WALNUT CREEK ADDITION

WICHITA, SEDGWICK COUNTY, KANSAS.

WALNUT CREEK ADDITION
(DRAINAGE)

PROJECT: WALNUT CREEK ADDN
JOB NO.:
DATE: 2-15-84
COPIES TO:
TO: CHRIS BREITENSTEIN
FROM: E. WOOTEN
REFERENCE: FINAL DRAINAGE PLAN

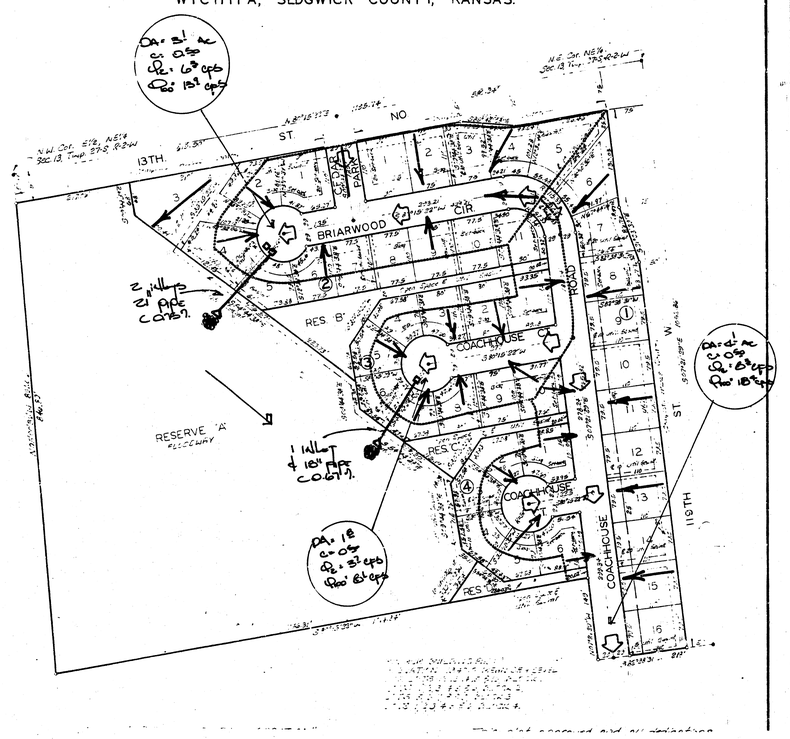
A) Drainage plan acceptable. Need guarantee of SWS.

Lots shall extend into floodway. Rear lot lines should conform to floodway boundaries.

Require offsite drainage easement to drain Coachhouse Court south to creek

B) SS layout acceptable (extend Beaumont (Continued thru any other) down from north)
Bldg setback = setting [illegible] 20' [illegible]
* Request addtl. R/W on SS 13th
near bridge
* Lot 3 partially (14.8' at curb)
* Change platting bdy to read "appropriate governmental agency."
